**ENVIRONMENTAL ASSESSMENT
FOR
LICENSE AMENDMENT REQUEST NUMBER 98-0007**

This proposed action involves the Davis-Besse Nuclear Power Station (DBNPS), Unit 1, Operating License Number NPF-3, Appendix A, Technical Specifications (TS). The proposed license amendment application involves TS 3/4.9.7, Refueling Operations - Crane Travel - Fuel Handling Building, and associated Bases; TS 3/4.9.11, Refueling Operations - Storage Pool Water Level; TS 3/4.9.12, Refueling Operations - Storage Pool Ventilation; TS 3/4.9.13, Refueling Operations - Spent Fuel Pool Fuel Assembly Storage, and associated Bases; TS 5.6, Design Features - Fuel Storage; and related changes to the TS Index.

Docket Number 50-346
License Number NPF-3
Serial Number 2550
Attachment 2
Page 4

Figure 3.9-1
Burnup vs. Enrichment Curves For
Davis-Besse Spent Fuel Pool Storage Racks

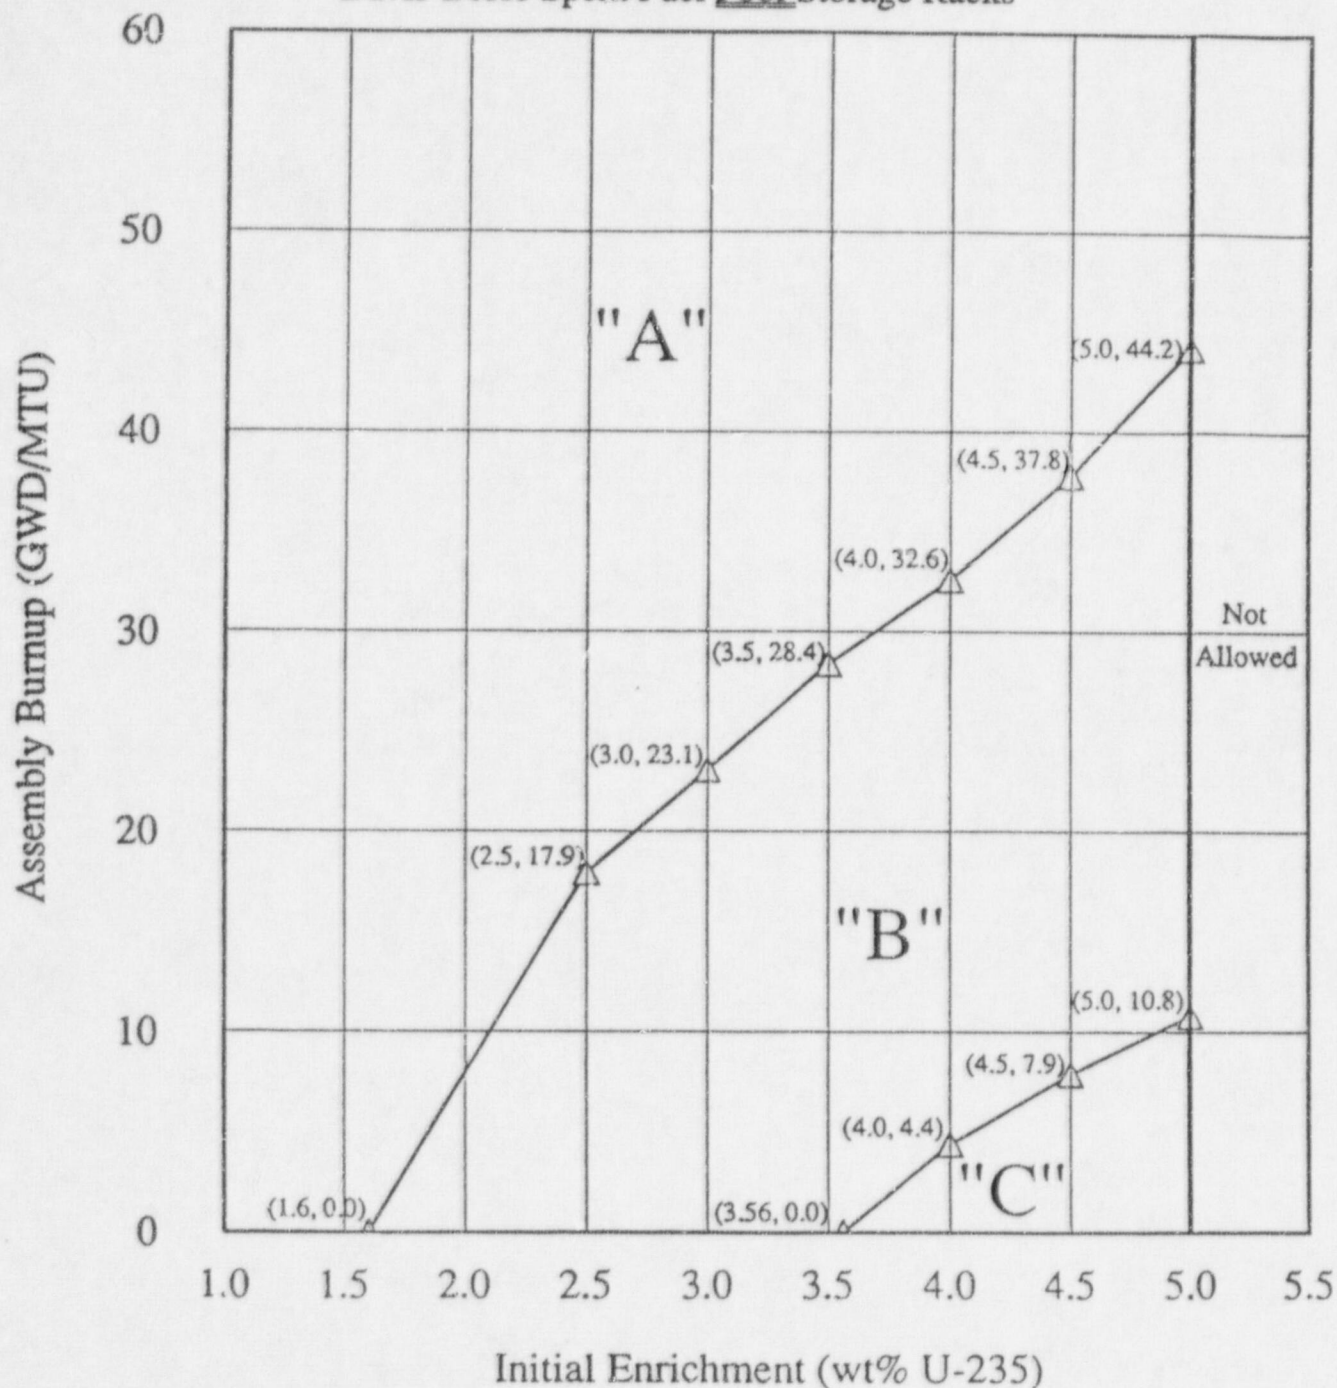
~~3.9.13~~ a. Fuel assemblies stored in the spent fuel pool shall be placed in the spent fuel storage racks in accordance with the criteria shown in Figure 3.9-1.

4.9.13.1 Prior to storing ~~a the~~ fuel assembly in the spent fuel pool or cask pit, verify by administrative means that the initial enrichment and burnup of the fuel assembly are in accordance with Figure 3.9-1 for the spent fuel pool, or Figure 3.9-2 for the cask pit, as appropriate.

Figure 3.9-2
Burnup vs. Enrichment Curve for
Davis-Besse Cask Pit Storage Racks

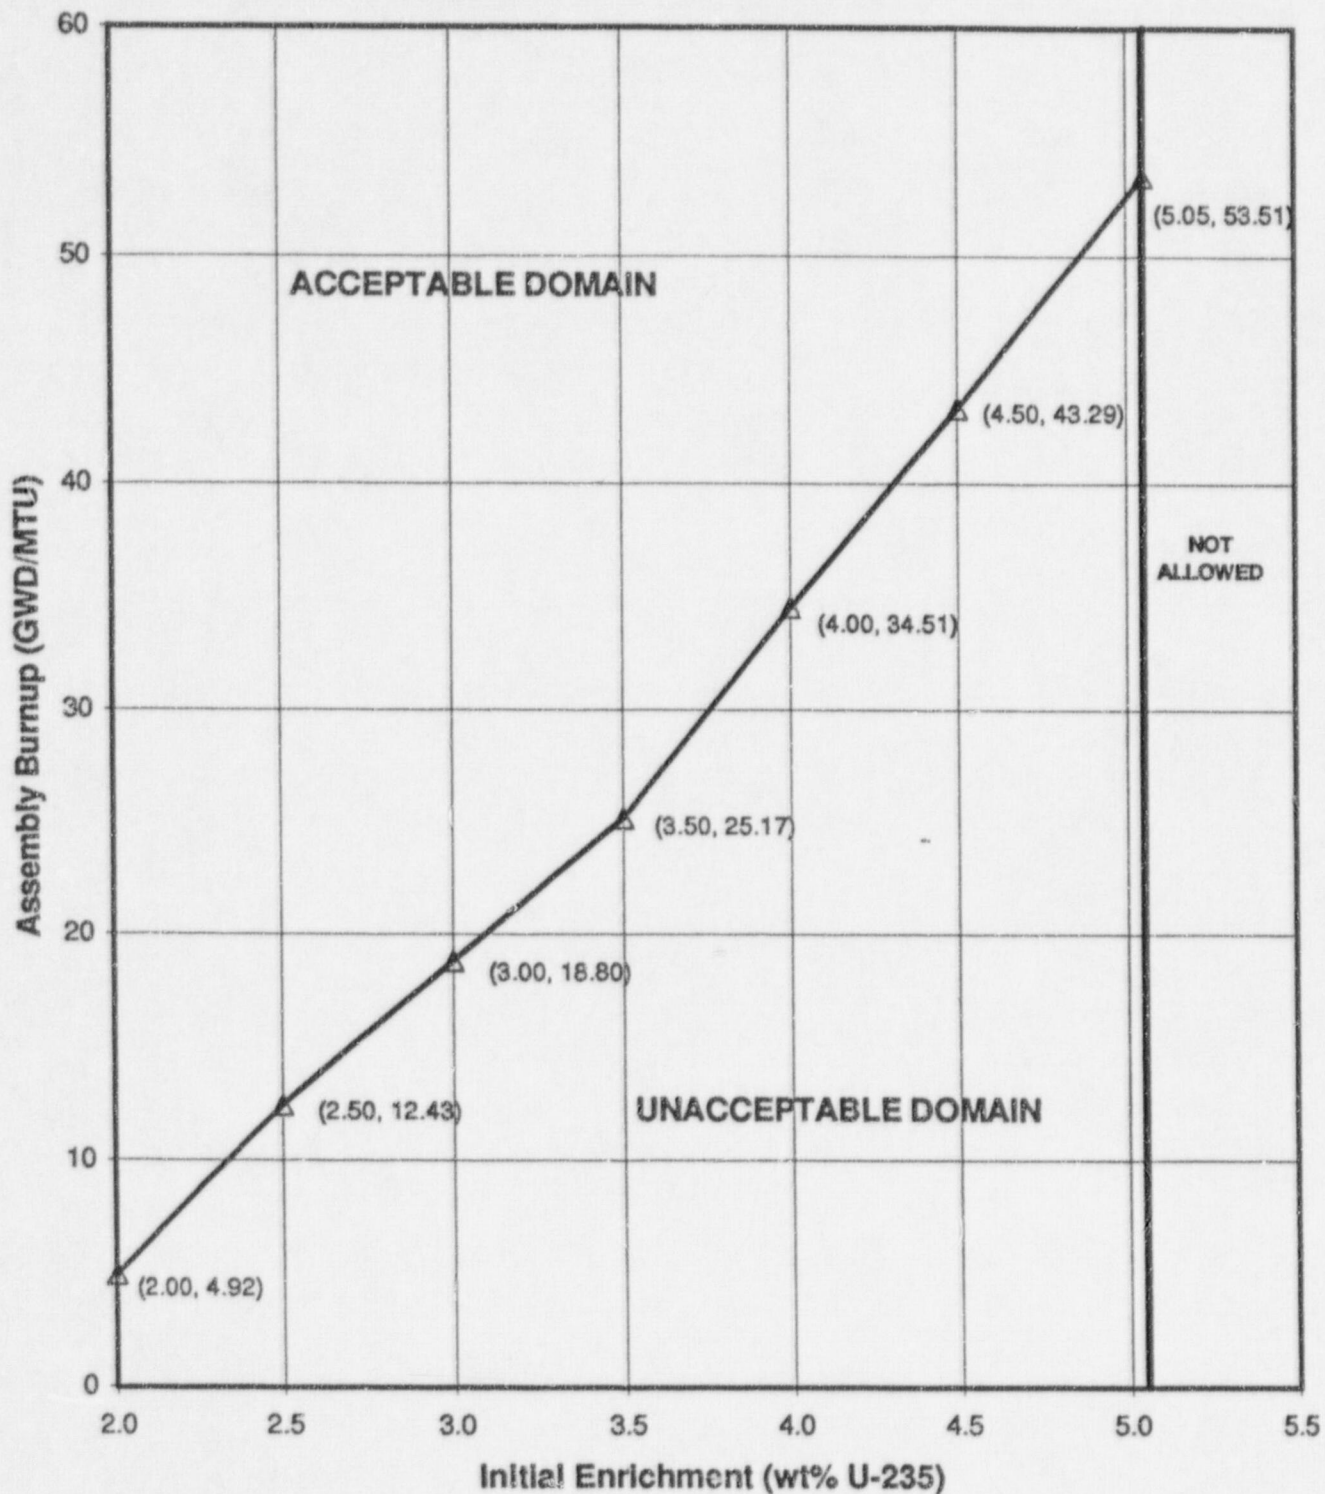
b. Fuel assemblies stored in the cask pit shall be placed in the spent fuel storage racks in accordance with the criteria shown in Figure 3.9-2.

Note: Fuel assemblies with initial enrichments less than 2.0 wt% U-235 will conservatively be required to meet the burnup requirements of 2.0 wt% U-235 assemblies.
